Project	COUNTY FLATS, SANDFIELDS
Project number	N297
Client	HALE CONSTRUCTION LTD
Title	BLOCK 01/02 ELEVATIONS 2/2
Drawing number	A012
Scale	1 : 100 at A1
Revision	H
Status	INFORMATION
Drawn	PC
Date	30.11.21

DESIGN CHANGES

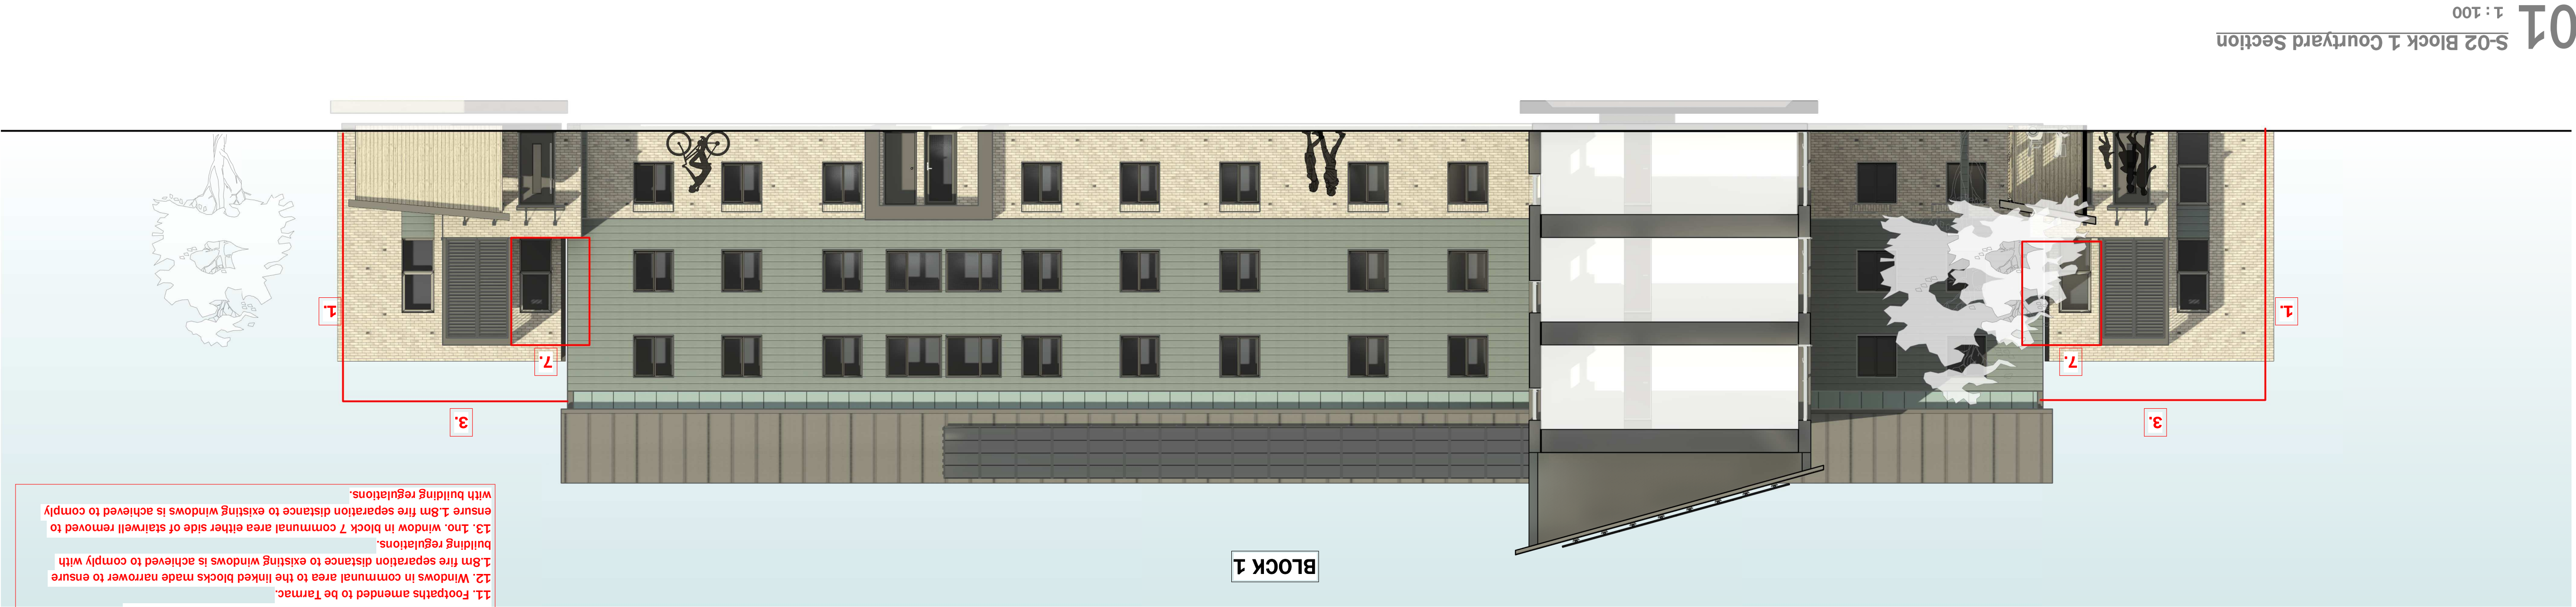
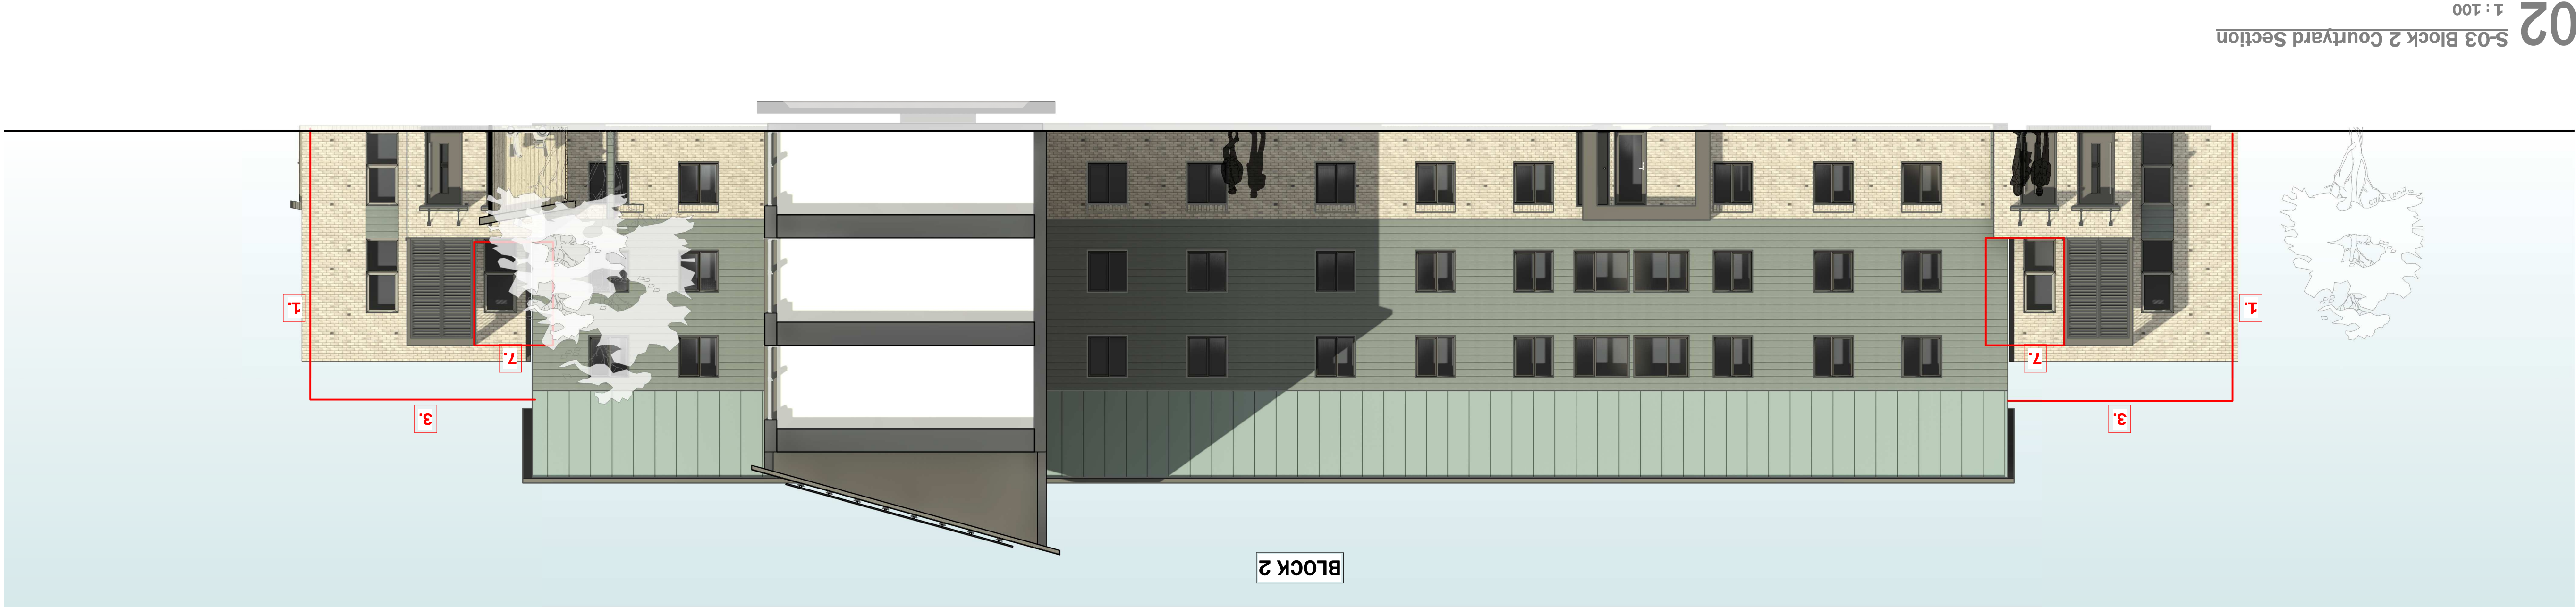
1. Modular end links re-positioned slightly off existing buildings, with the party wall straightened and porch projections aligned with this wall, to ensure modular construction can be achieved off site.

2. Windows have been slightly re-positioned to the new build to suit the structural design of the modular units and the constraints of the timber frame.

3. Parapet to modular and blocks have been lowered by approx 500mm to comply with the structural wind loadings and timber frame design.

4. Corner windows have been removed and replaced with 2no. Windows on either corner, again due to the structural and timber frame design of the blocks.

5. PV panels have been omitted from the end modular units to suit the structural and timber frame design of the blocks.

6. Ground floor Juliet balcony added to existing flats to provide better security whilst ensuring the open areas remain as communal spaces.

7. Air source heat pump external enclosure amended to be single storey over entrance canopy to end link blocks.

8. External air source lowered enclosure handed to provide internal riser/access requirements for maintenance.

9. Buggy/cycle store added to block 6 and 7 parking courtyards.

10. Bin stores slightly re-positioned to suit existing drainage runs, with bin store near block 6 amended in size to suit located of bedroom window.

11. Footpaths amended to be Tarmac.

12. Windows in communal area to the linked blocks amended to comply with 1.8m fire separation distance to existing windows is achieved to comply with building regulations.

13. 1no. window in block 7 communal area either side of stairwell removed to ensure 1.8m fire separation distance to existing windows is achieved to comply with building regulations.
